**AUSTRALIAN NUCLEAR ASSOCIATION INC.**

**Submission to**  
**Australian Energy Market Operator (AEMO)**  
**on**  
**CSIRO GenCost 2023-24 Consultation Draft Report**  
**6 February 2024**

Figure 1. Capital costs of recent nuclear projects in USD per kW. Ref: ETI Nuclear Cost Drivers Project, Ingersoll, Gogan, Herter and Foss, Sept 2020. <https://esc-production-2021.s3.eu-west-2.amazonaws.com/2021/08/ETI-Nuclear-Cost-Drivers-Full-Report-FINAL.pdf>

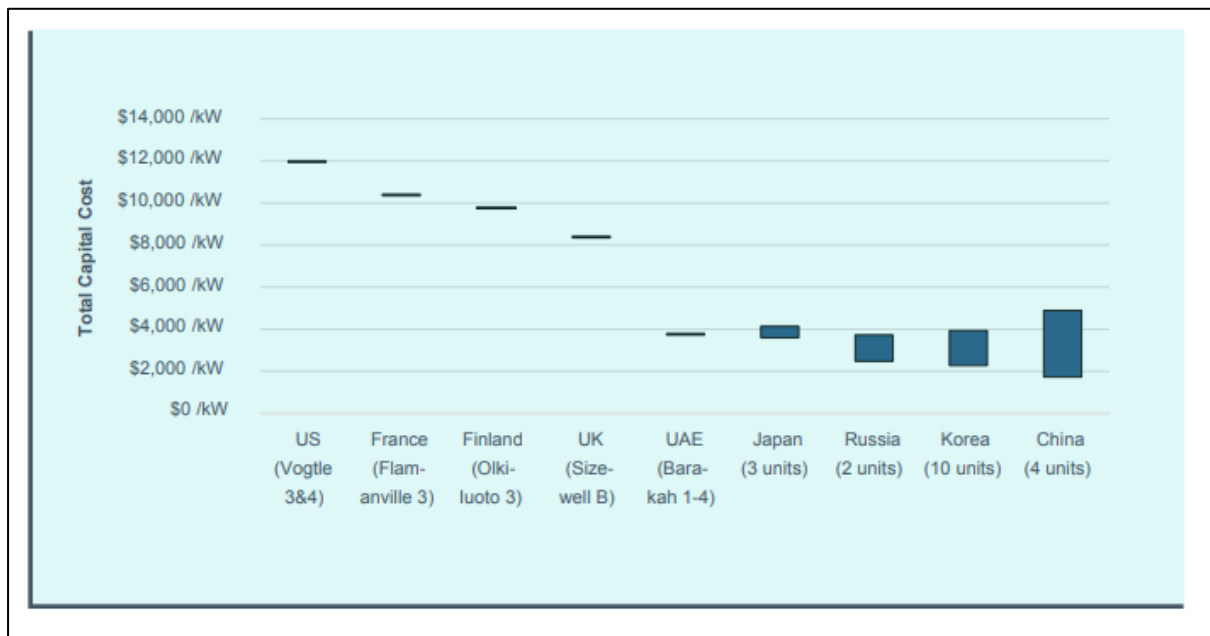
The capital costs of all projects in Figure 1 are much less than the CSIRO GenCost cost estimate for SMRs of AUD31,138 per kW for 2023 (approx USD20,400). The CSIRO GenCost estimate for SMR reduces to AUD 15,959 in 2030 (approx. USD10,500) in the *Current Policies* scenario (Apx Table B1).

The capital cost of the UAE nuclear plants in Figure 1 is particularly relevant as it was a country with no nuclear when UAE decided in 2008 to have nuclear power and subsequently ordered 4 large power reactors from the Korea Electric Power Co. (KEPCO). Three of these four reactors are now operating.
